PUBLIC DRAFT

Groundwater Sustainability Plan

APRIL 2019

Figure 1-1 - Cuyama Valley Groundwater Basin

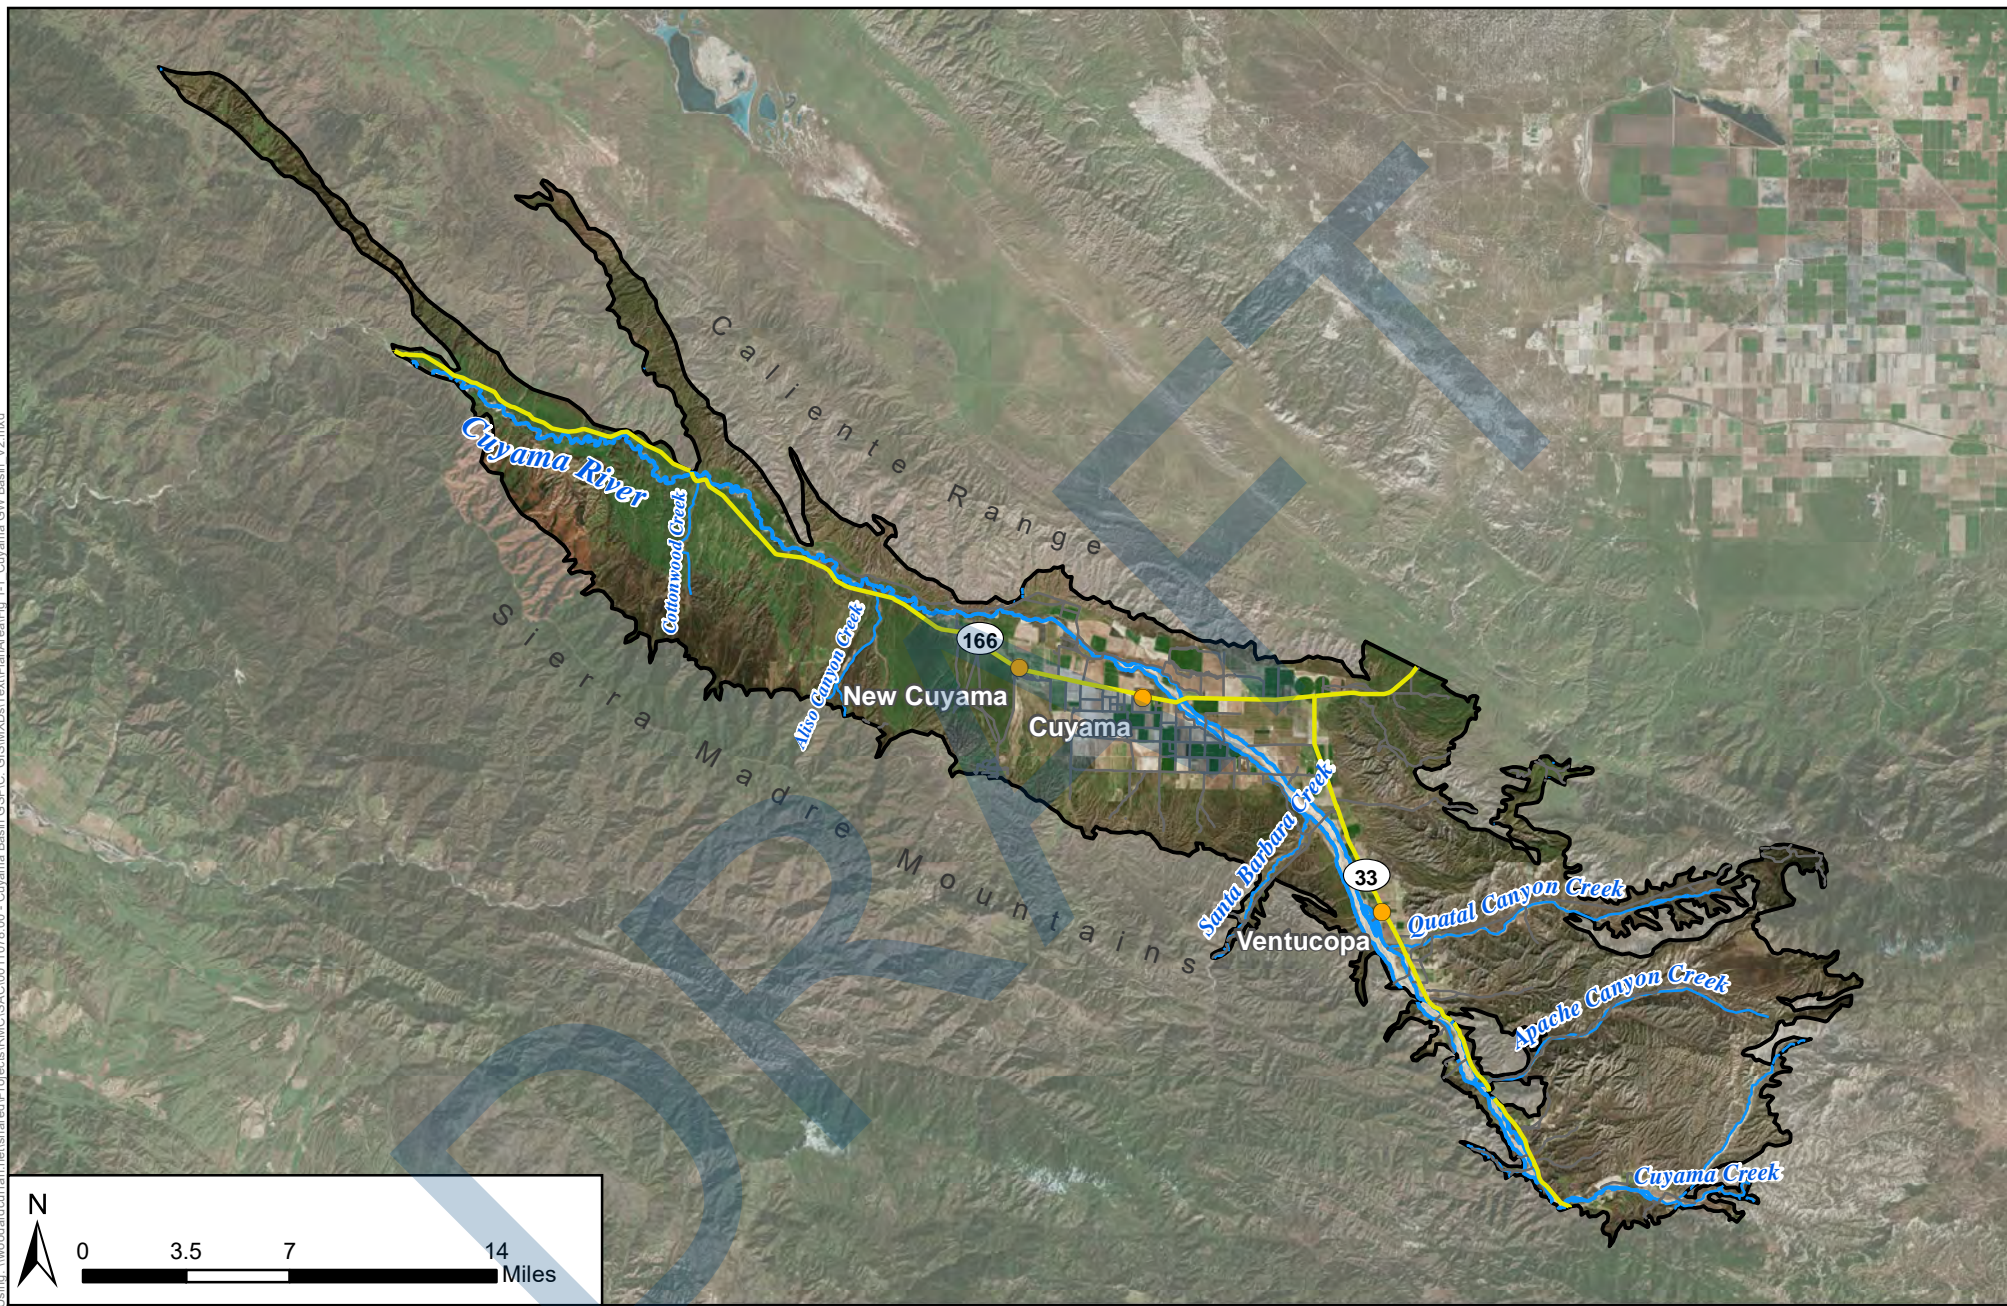
39	1.2	1	2	It is beneath the Cuyama...	Comment "It is beneath the Cuyama Valley, which is bounded by the Caliente Range to the northwest and the Sierra Madre Mountains to the southeast": these 2 ranges should be shown on the figure.	Labels for these ranges will be added to Figure 1-1.
40	1.3	1	4	The Basin also encompasses...	Comment "Wells Creek": not labeled on figure	Creek labels will be added to Figure 1-1
41	1.3	1	4	The Basin also encompasses...	Comment "Quatal Canyon drainage": not labeled on figure	Creek labels will be added to Figure 1-1
42	1.3	1	4	The Basin also encompasses...	Comment "Cuyama Creek": not labeled on figure	Creek labels will be added to Figure 1-1
43	1.3	2	1	Figure 1-2...	Comment "CBGSA": not mentioned in legend	The legend will be updated to note the CBGSA boundary
44	1.3	4	7	Its jurisdictional coverage...	Edits "Ventura County encompasses has jurisdiction over the southeastern area of the Basin (covering 120 square miles), including the area east of Ventucopa."	Comment accepted

69	1.2				Comment: Add labels on figure for Caliente Range and Sierra Madre Mountains	Labels for these ranges will ba added to Figure 1-1.
70	1.3				Comment: combine Figure 1-1 and 1-2?	Creek labels will be added to Figure 1-1
71	1.3				Label Wells Creek, Santa Barbara Creek, Quatal Canyon, and Cuyama Creek on Figure 1-1	Creek labels will be added to Figure 1-1
72	1.3	2	3	The CBGSA was created..	Edit: Remove "E" from "JEPA"	W&C will confirm the correct acronym.

Figure 1-2 - Cuyama Valley Groundwater Sustainability Agency Boundary

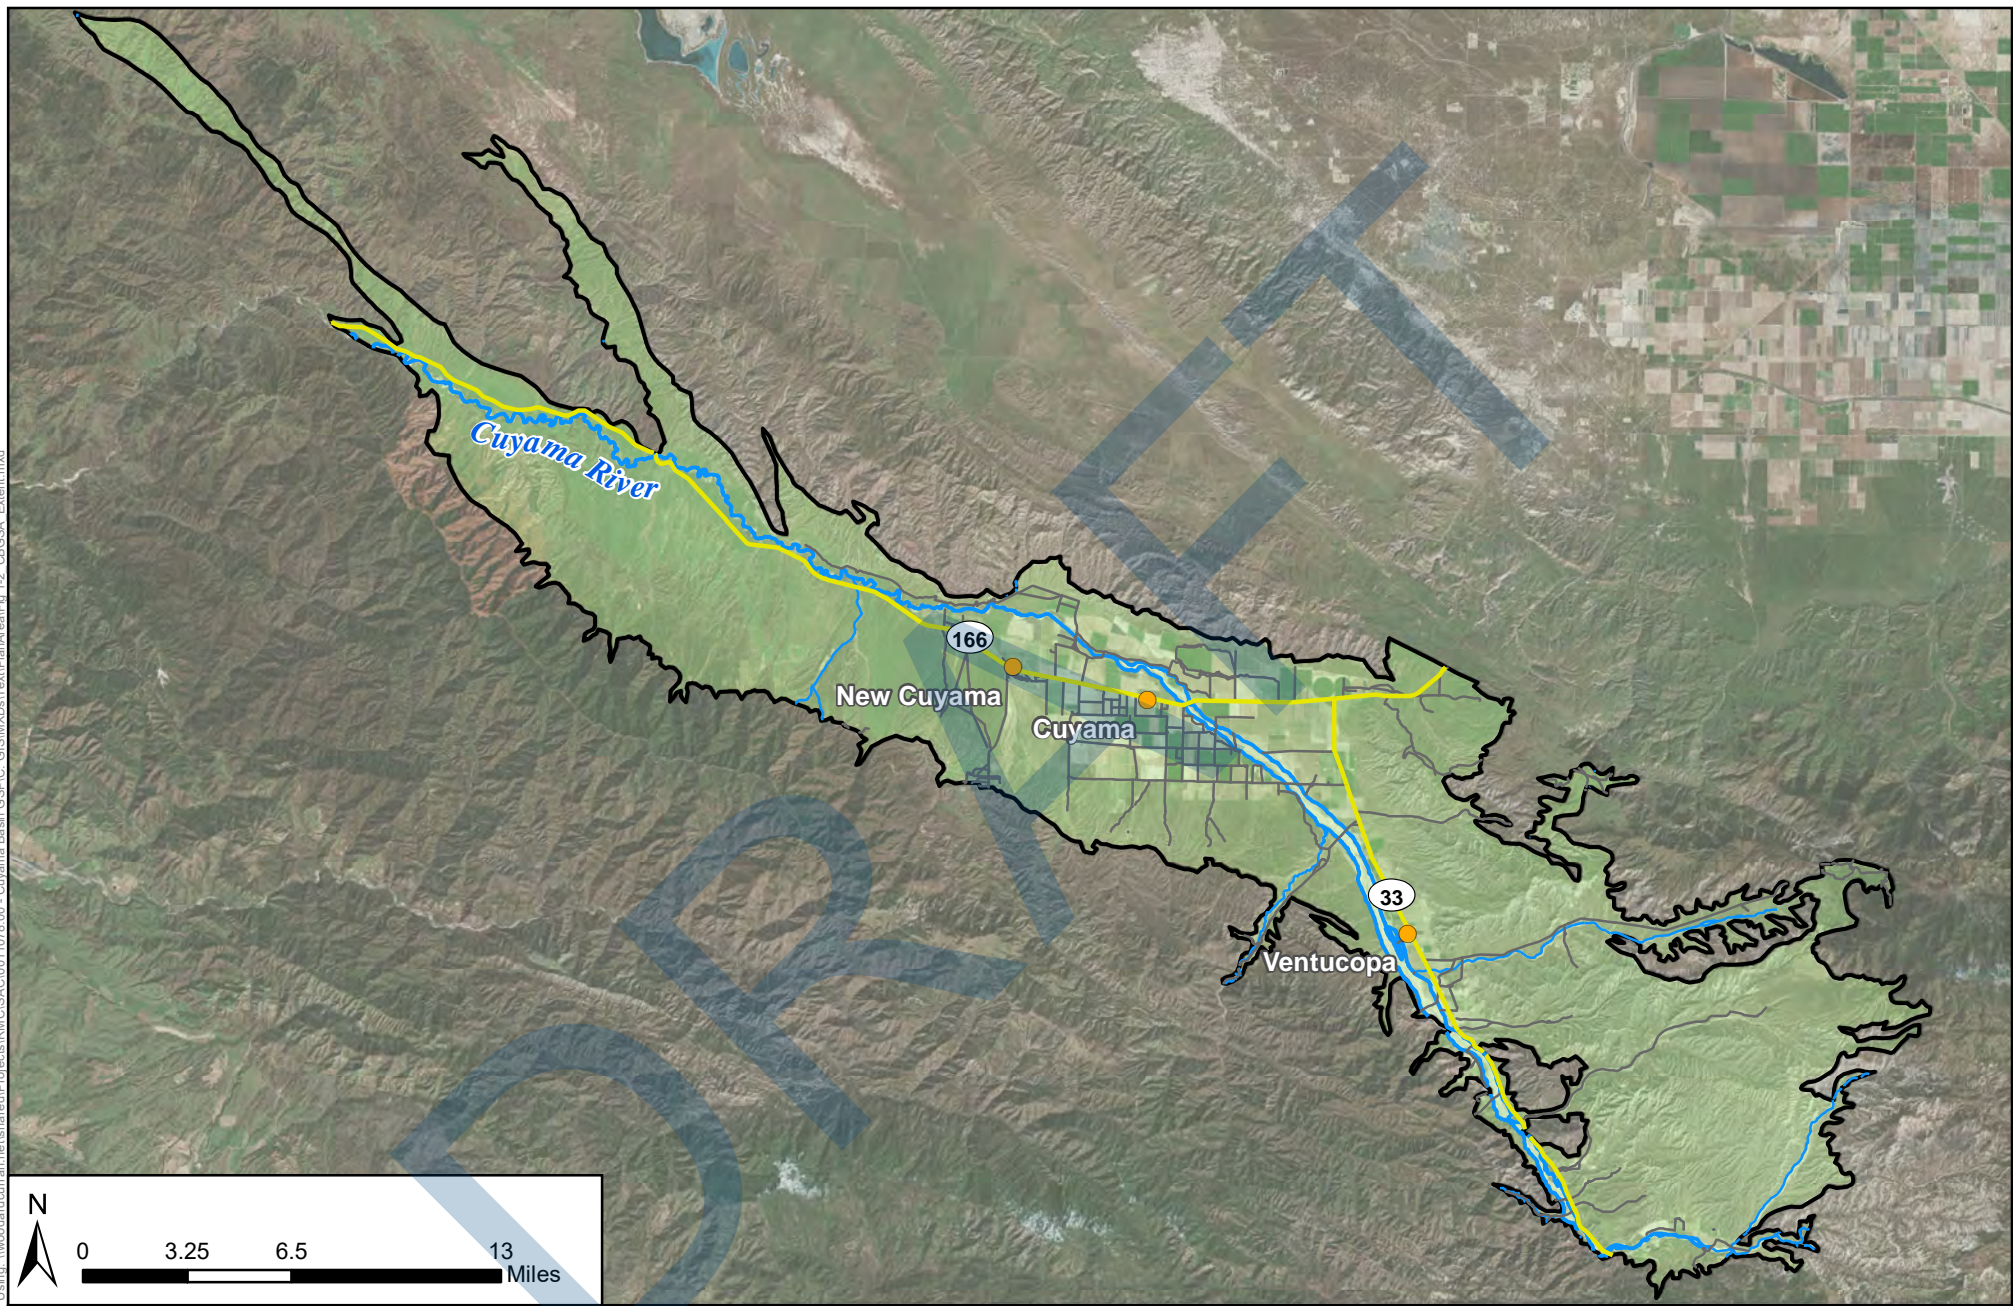
Comment #	Section	Section Paragraph #	Paragraph's Sentence #	Sentence Starts with, "...	Comment	Proposed Response
73	1.3				Comment on Figure 1-2: Figure 1-4 shows County Boundaries? Figure 1-2 Not Needed Combined w/ Figure 1-1.	The Figures have been organized to clearly show compliance with SGMA requirements and therefore, the contents and numbering of each figure will not change.
74	1.3	3		Figure 1-3 shows...	Comment on entire paragraph: P. 3 coss draft 2018 SGMA Prioritization. High Priority	Figure 1-3 will be updated to reflect the new prioritization of the Cuyama Valley Groundwater Basin
75	1.3	4			Comment on Figure 1-4: Move to Figure 1-2A	The Figures have been organized to clearly show compliance with SGMA requirements and therefore, the contents and numbering of each figure will not change.
76	1.3	5			Comment on Figure 1-5: Figure 1-2b	The Figures have been organized to clearly show compliance with SGMA requirements and therefore, the contents and numbering of each figure will not change.

Figure 1-4 - Counties Overlying Cuyama Basin
 Cuyama Basin Groundwater Sustainability Agency
 Cuyama Valley Groundwater Basin Groundwater Sustainability Plan
 April 2019

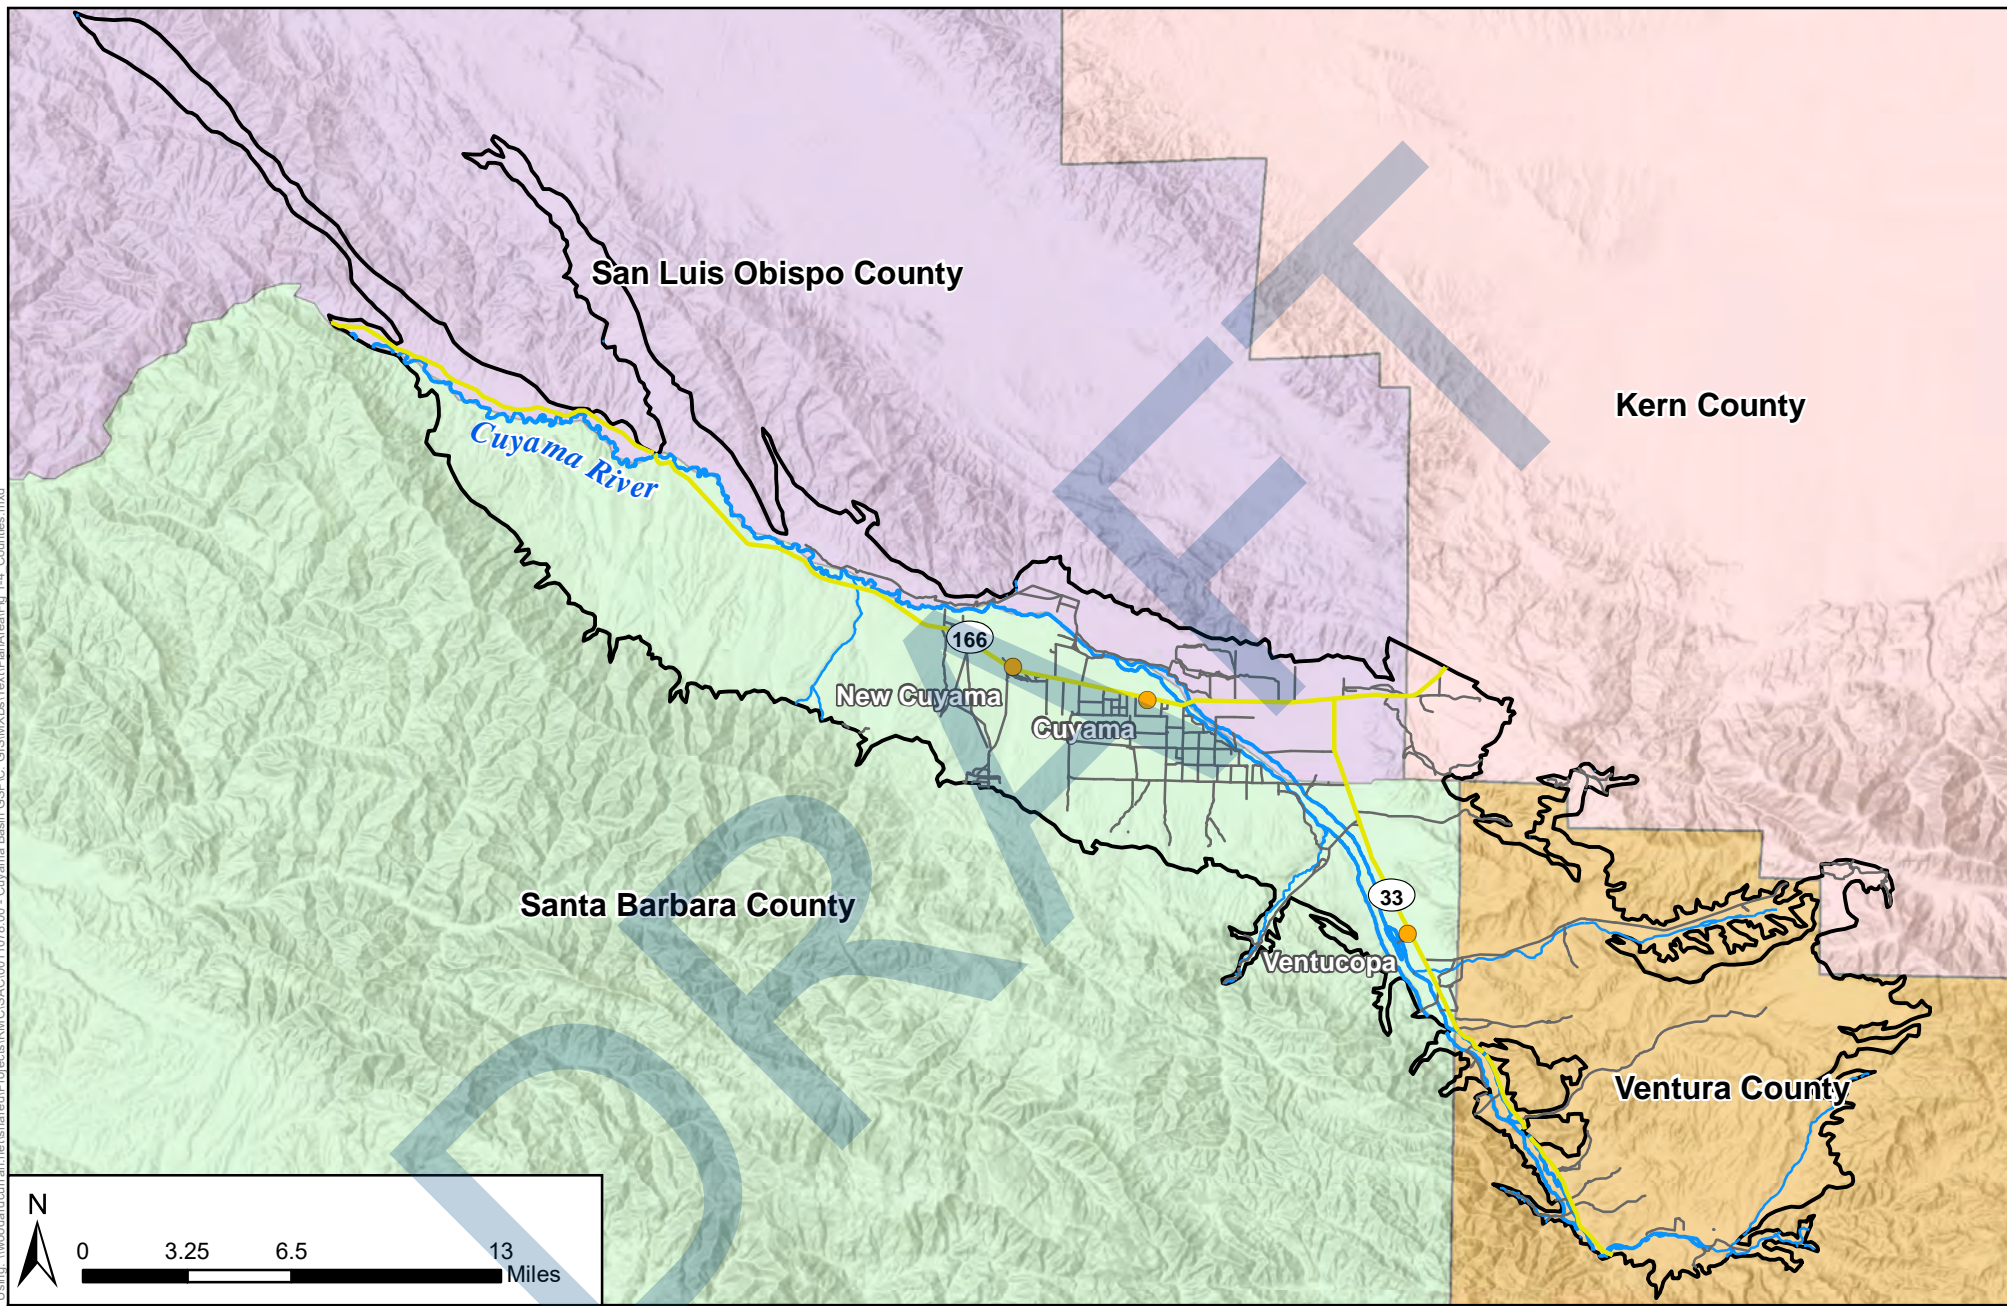
85	1.3			Figure 1-4	Comment: Figure 1-2?	The Figures have been organized to clearly show compliance with SGMA requirements and therefore, the contents and numbering of each figure will not change.
86	1.3			Figure 1-5	Comment: Suggest using entire Basin Scale? Instead of 200 median	The scale of Figure 1-5 will be modified to show full basin.
87	1.3			Figure 1-3	Comment on Medium or all Priorities: Still correct> Draft 2018 SGMA Plan is High	Figure 1-3 will be updated to reflect the new prioritization of the Cuyama Valley Groundwater Basin
88	1.3			Figure 1-6	Comment: Does this include Harvard? All ag?	Land use for additional years, including 2016, is currently being processed and will be shown in the next revision of the plan area document. These land use datasets only show irrigated agricultural lands and therefore do not include non-irrigated range and pasture land. However, water use from these other land areas will be accounted for in the numerical model and water budget as part of the GSP.
